Observation Report

Re: Meadow Creek Condominiums, Vail, CO
(Building L)
Project No. 0307-19 L

**EXISTING DECK
 FRAMING LAYOUT**

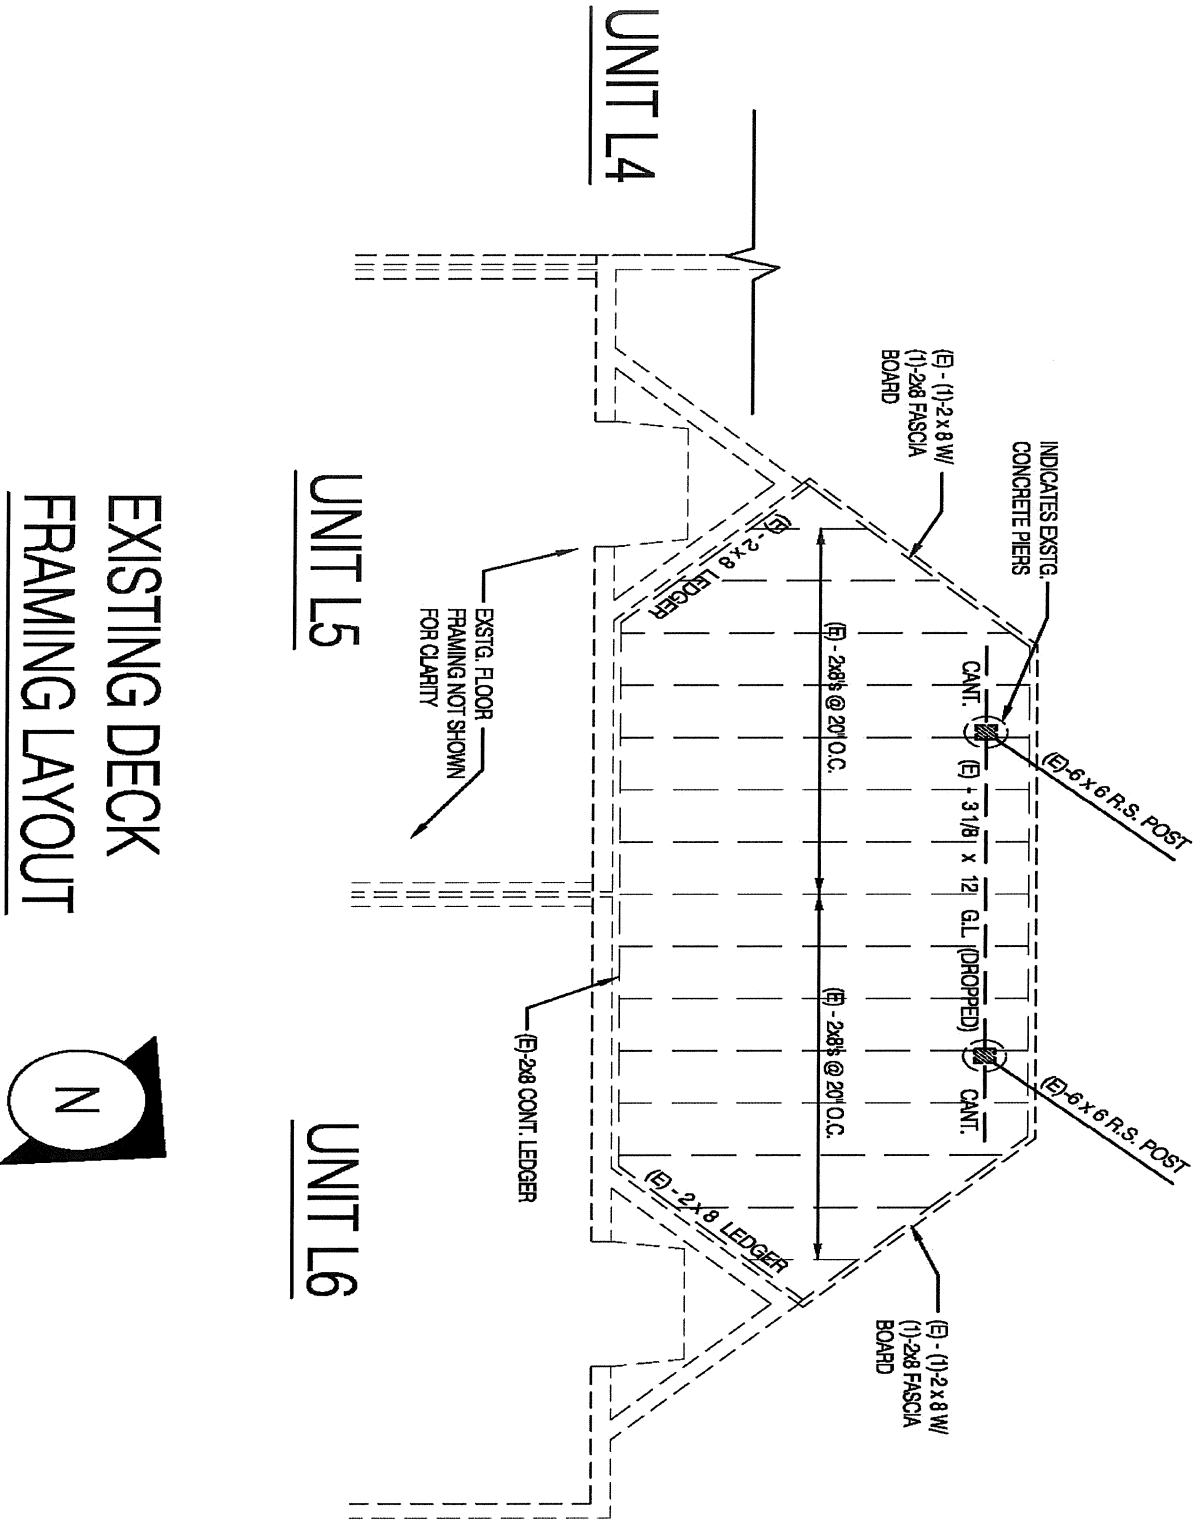
Building L consists of six units and units L5 and L6 stagger from the northwest towards the northeast approximately 16 feet from the remainder of the units. The decks appear to have been remodeled at some point in time. The exterior decks are located on the west side of the building and are approximately 10'-3" above the finished grade. They extend approximately 9'-10" from the building and the lengths of the decks vary from unit to unit. There is a framed partition wall that divides the decks in half. This partition wall appears to be located between the two units at the party wall. The decks are accessed by an exterior door located on the west side of each individual unit and an exterior set of stairs for units L2 and L4. The exterior decks appear to be framed with 2x wood decking on a combination of 2x8 dimensional lumber joists, glulam beams and timber posts. (See Image A, B, C, and attached layouts)
